Service Bulletin 497

Affected Models Bonneville, Bonneville T100 and Bonneville T100 Black

Subject Ignition Switch

1. Ignition switch
2. Fixings
3. Spring washer

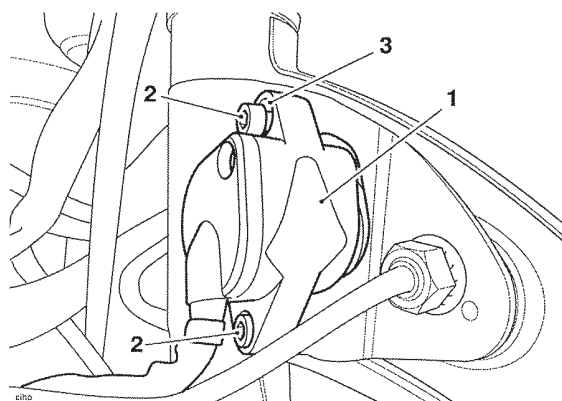
We have identified that there is a possibility that the spring washers for the ignition switch screws may be missing on the above models. Dealers are requested to remove and refit the ignition switch screws with spring washers.

1. Fit the spring washers to the fixings. Refit the ignition switch to the headlight mounting bracket and tighten the fixings to **5 Nm**.
